Building Permit Application

Permit No.: B14000590

Building Address: 12130 Hayland Farm Way
 City: Ellicott City State: Md Zip Code: 21042
 Suite/Apt. #: _____ SDP/WP/BA #: _____
 Census Tract: _____ Subdivision: Walnut Creek
 Section: _____ Area: 33,000 Lot: 28
 Tax Map: 28 Parcel: 49 Grid: 17418
 Zoning: _____ Map Coordinates: _____ Lot Size: 33,000

PERMIT SITE PLAN
LOT 28
 12130 HAYLAND FARM WAY
WALNUT CREEK

FIRST FLOOR PLAN

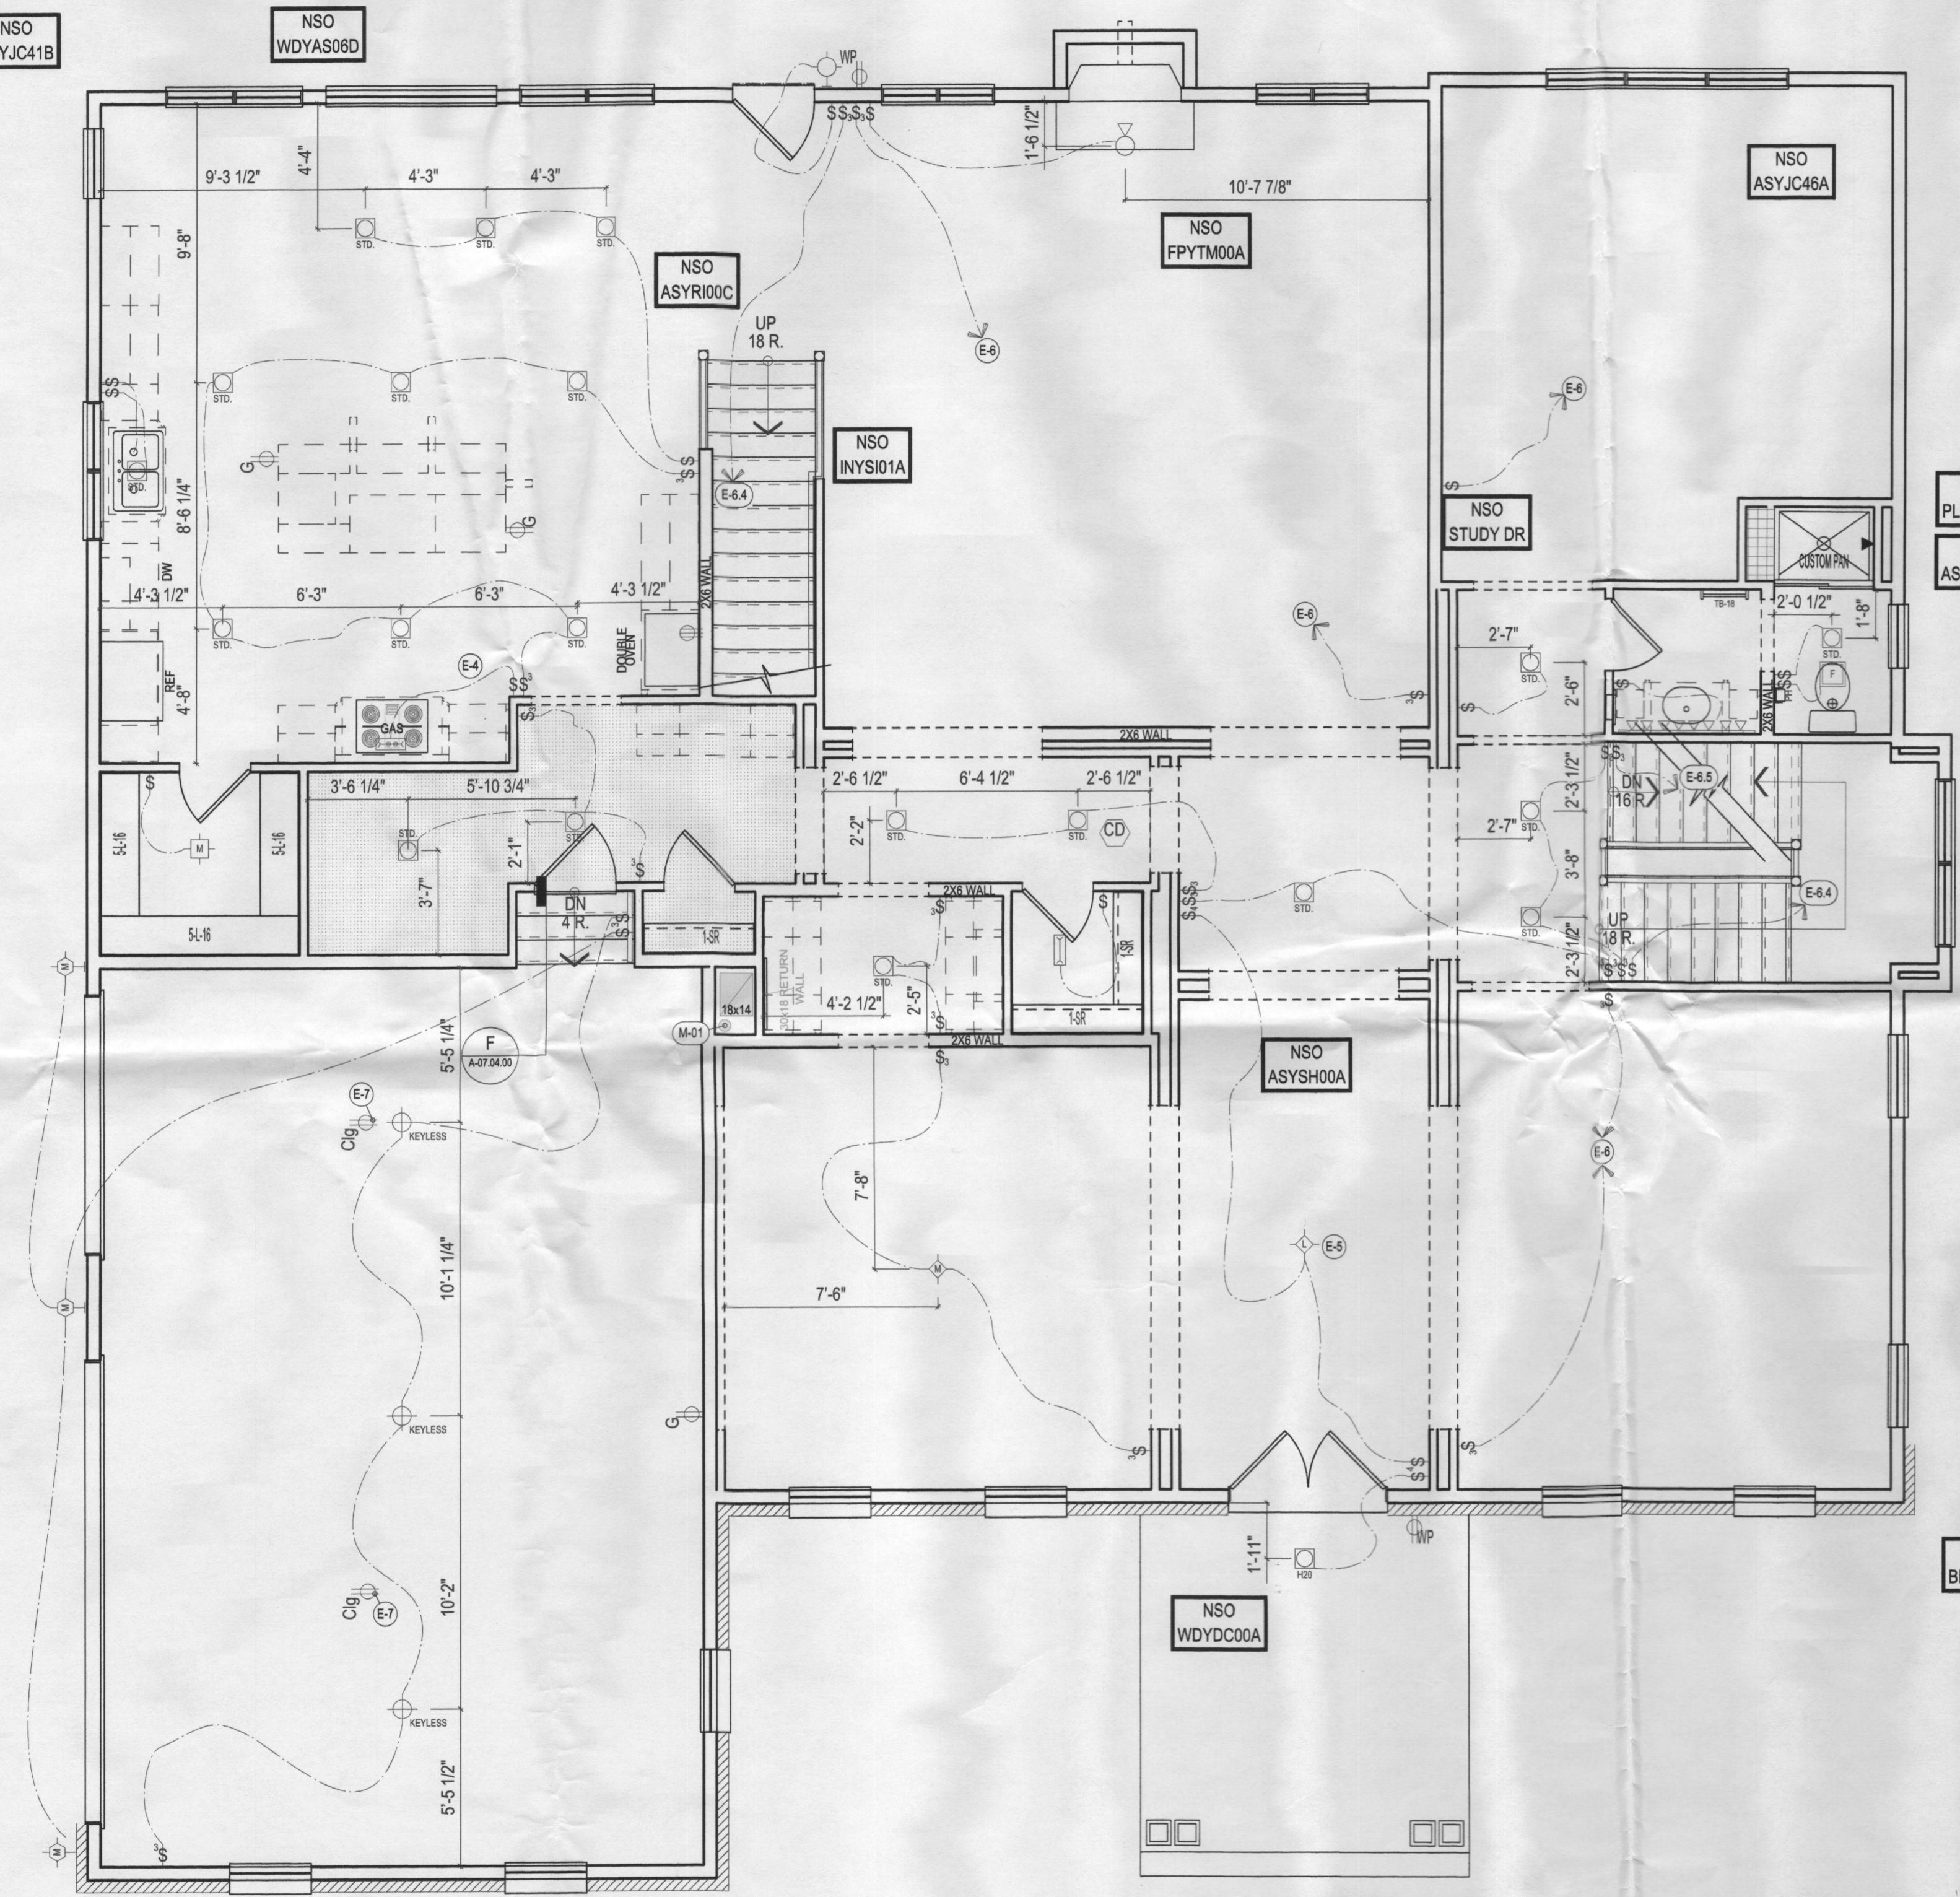
We would consider that study a bedroom. The closet is not the determining factor for defining a bedroom in our code. The bathroom access in that case is something we would call direct. It is right outside the room. You could do the doorway fix on either room in order to keep the bathrooms as-is

Refer to the email I just sent regarding lot 25. This lot also has 6 bedrooms counting the den in the basement and the study on the 1st floor. Please revise in similar fashion. Thanks.

NSO STUDY DR

STUDY DR Make opening into study a 4/0 Cased opening to satisfy county requirements.
